Z-56  
(2017)

**PROVIDENCE ESTATES**  
 REZONING PLAN

LAND LOTS 26, 27, 46 & 47  
 16TH DISTRICT, 2ND SECTION  
 COBB COUNTY, GEORGIA  
 JUNE 13, 2018

**PETITION NO:** Z-56

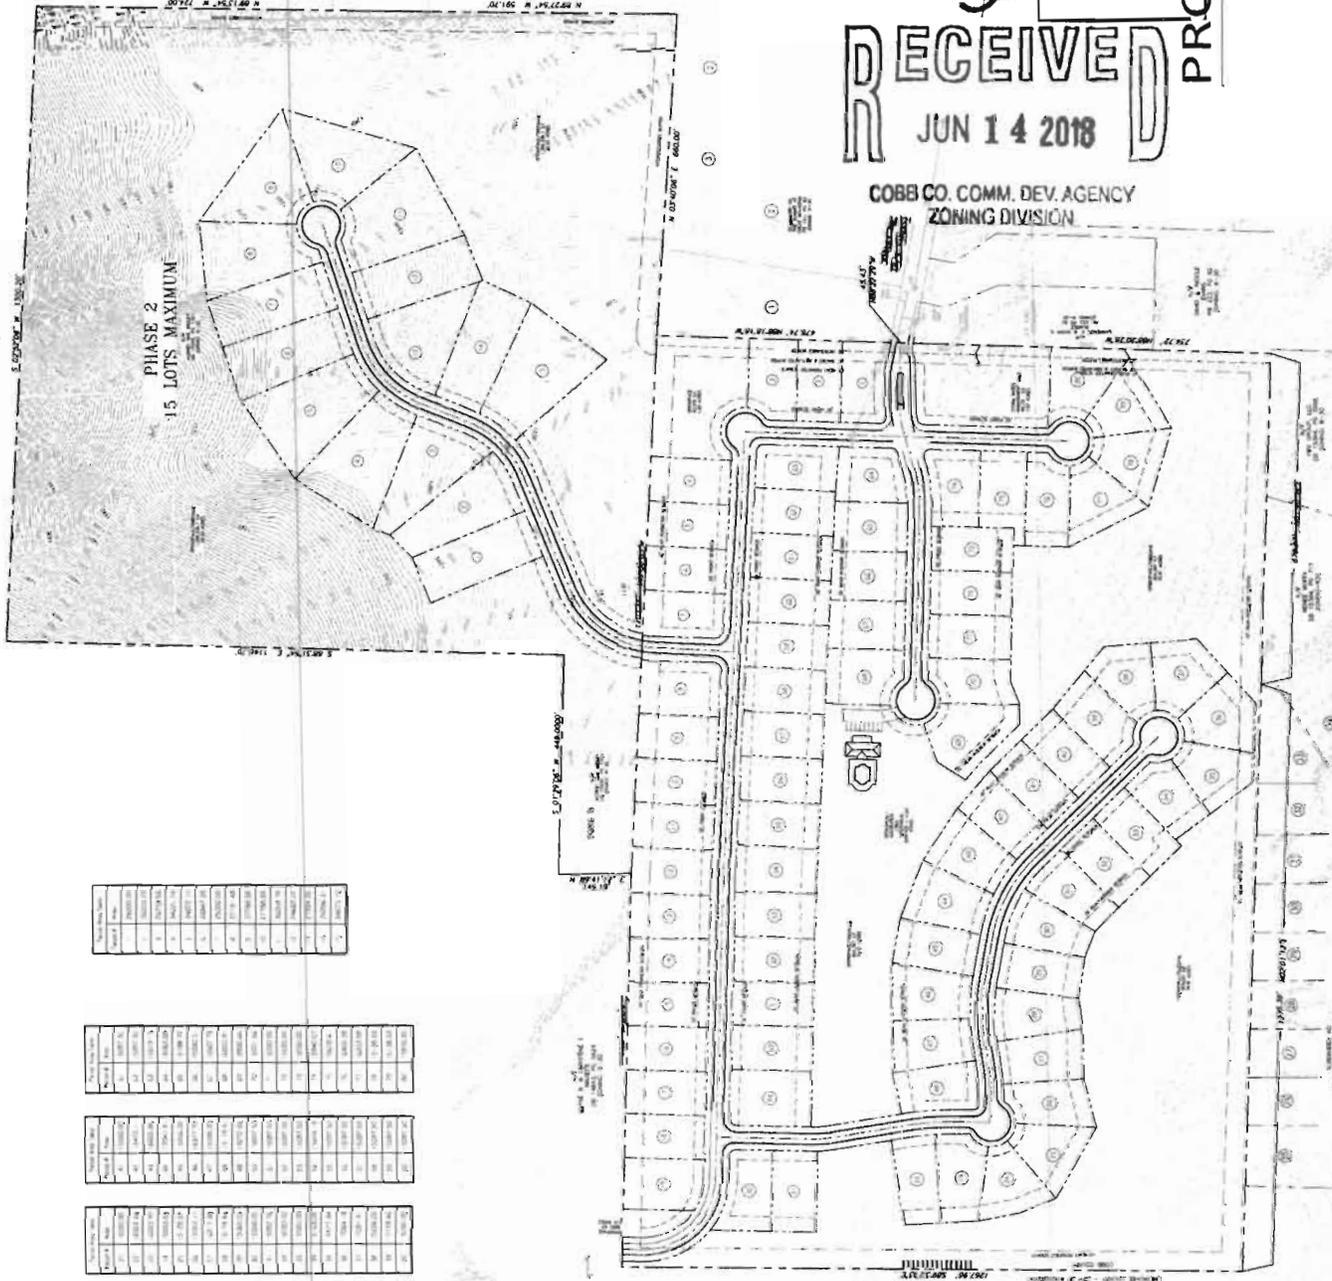
- 1.) Impervious surfaces of amenity areas should be subtracted from the total area to determine Net Buildable Area. Please provide acreage of the impervious surface of amenity area on site plan. Also, please note on plan that no floodplains, wetlands and/or cemeteries are evident on site, if that is indeed the case.

- 2.) Revised April 17, 2018 Stip. Letter to be consistent with revised Site Plan dated June 13, 2018. Item #1 depicts 45% of the site will be open space. The June 13, 2018 revised plan shows 51% when accounting for .26 acres of Amenity Area.

- 3.) Slopes greater than 25 percent must be included in the required open space, but shall allow for perpendicular (except when non-perpendicular is necessary to satisfy drainage/storm water requirements) utility and access crossings, when necessary. Based on GIS generated slope analysis, there are several lots that encroach into slopes greater than 25%.

- 4.) The buffer area on the southern and eastern portions of the subject property show 40 foot. Item #2 of the April 17, 2017 Stipulation letter says 50 foot. Please show 50' undisturbed buffer along the

southern and eastern portions of the subject property, as well as to the rear of lots 42 and 43 on the western side of subject property.

- 5.) Either on the plan or in stipulation letter include language referencing fencing that is compatible with the architecture/landscape/design of development shall be established along lot lines that are contiguous to open space.
- 6.) A Conservation Easement must be recorded in the mandatory subdivision covenants and with Cobb Superior Court, thereby protecting the “Open Space” from development in perpetuity as owned by the mandatory Home Owners Association. Conservation Easement application must be submitted to the Planning Division before final plat approval.

**Revised comments based plan dated June 13, 2018**

1. This site is located on the northern portion of Wigley Road. Phase 1 of the site lies on a steep ridgeline and drains in three directions. The majority of the site (40%) drains to the south roughly parallel to Wigley Road. Approximately 35% of the site drains to the northeast along Wigley Road into Cherokee County. The remaining 25% of the site drains to the west into and through the adjacent Falcon Crest Subdivision. The site is predominately wooded with steep slopes ranging from 12 to 40%. Phase 2 lies east of Wigley Road. Except for portions of the northeast and northwest corners, the majority of the Phase 2 parcel drains to the west into and through Lots 1 – 4 of the adjacent Summit at Sweat Mountain Subdivision. Slopes for this parcel appear to be 35% or greater. Site layout for this development needs to be sensitive to the steep topography with grading limited to the the R/W and building pads only.

2. Although there are two parcels identified on the site plan as reserved for stormwater management, it is likely that a third onsite detention pond will be required to adequately control runoff from the development to the west. This pond would most likely be located to the rear of Lot 25.

3. As indicated in the Downstream Conditions comments above, there is an existing lake located approximately 300 feet downstream. A pre- and post-development sediment study will be required to document any sediment impacts to this lake. Elevated onsite erosion control measures will be required due to the steepness of the site.

4. A downstream headwater pool analysis will be required for the existing receiving culvert in Falcon Crest S/D to verify no adverse impact. The basement at 2254 Hawk Trace is located significantly below the low point of the road.

The parcel to the northeast of the site has current access on Wigley Road. The current site plan shows this access removed. Recommend providing public access to this parcel from the newly aligned roadway.
